**CHANDIGARH  
HOUSING BOARD**  
A CHANDIGARH ADMINISTRATION UNDERTAKING

**Subject :** Additional construction / violations in Duplex Flats in Sector 41-A, Chandigarh.

H. No. 852/1, SEC. 41-A, CHANDIGARH

STANDARD DESIGN OF  
NEED BASED CHANGES FOR  
M.I.G. (DUPLICATE)  
SECTOR 40-B, 41-A & 47-D  
CHANDIGARH. (U.T.)

FIRST FLOOR PLAN

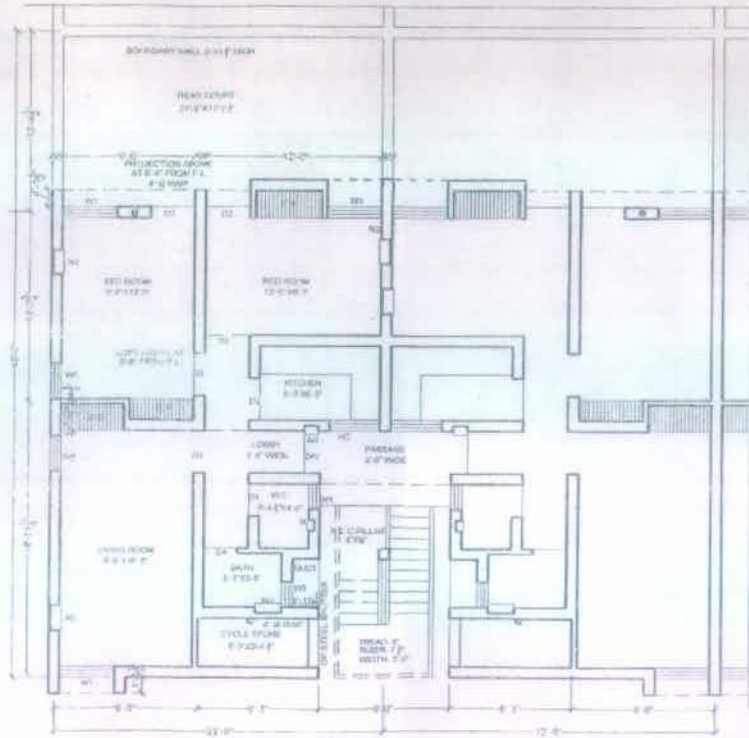
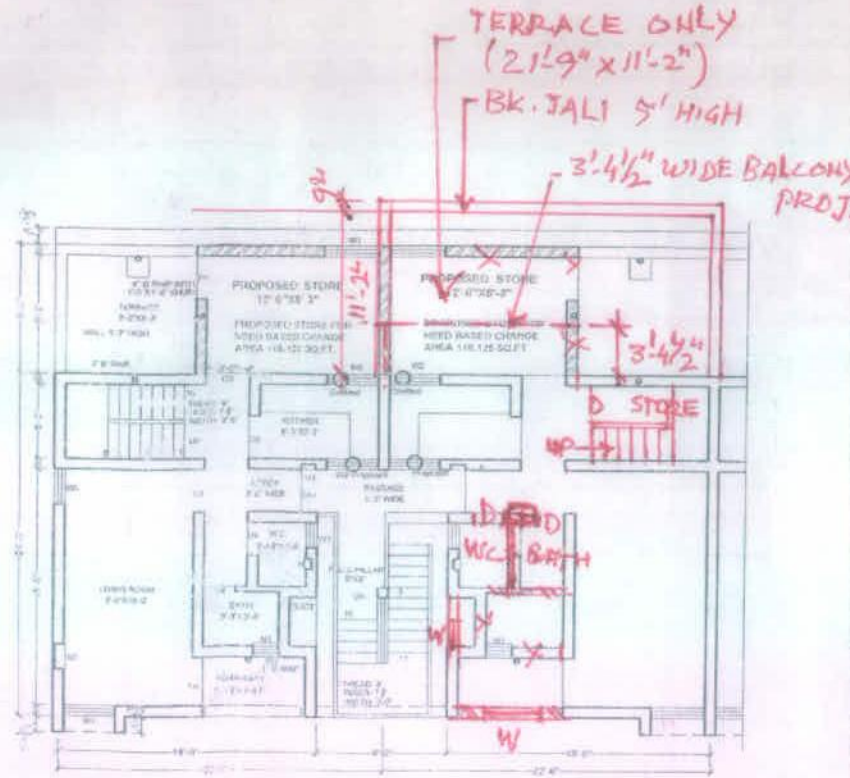
- 6) FOR ANY OTHER DETAIL REFER TO CHB. NO. 1 JOB NO. 2205
- 7) ADDITIONAL CONSTRUCTION HAS BEEN SHOWN HAS HATCHED

Construction of additional room at first floor is not allowed for the MIG(Duplex) DUs in Sector 41-A as per the decision of the Board taken in the 408<sup>th</sup> meeting held on 13.11.2017 vide agenda item no. 408.2.2, which is regarding the Civil Writ petition no. 2309/2014 - Resident Duplex Flats Association Vs. Chief Administrator, UT, Chandigarh and others

As such, you are advised to remove / set right the violations as per standard drawing of CHB to ensure the structural stability / safety at the earliest positively under intimation to this office along with Structure Stability Certificate issued by the empanelled Structural Engineer by Chandigarh Administration, failing which the action will be taken by CHB as per rules / policy and as per the directions of Hon'ble High Court.

H. No. 852/1, SEC. 41-A, CHANDIGARH

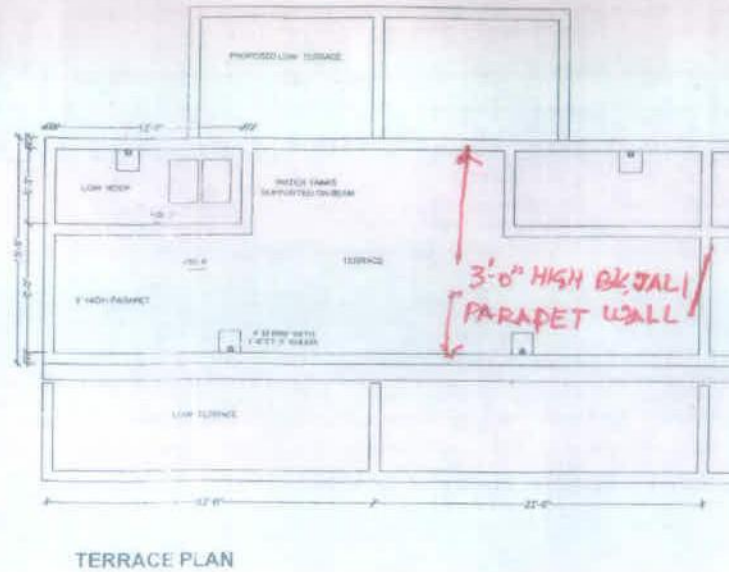
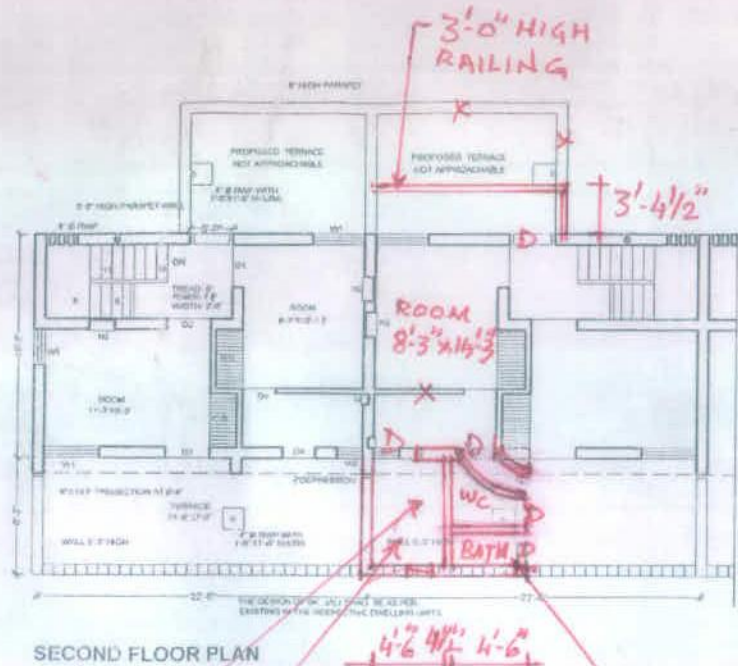
6. FOR ANY OTHER DETAIL / NOTES REF. DRG. NO. 2 JOB NO. 2205
  7. ADDITIONAL CONSTRUCTION HAS BEEN SHOWN HAS HATCHED
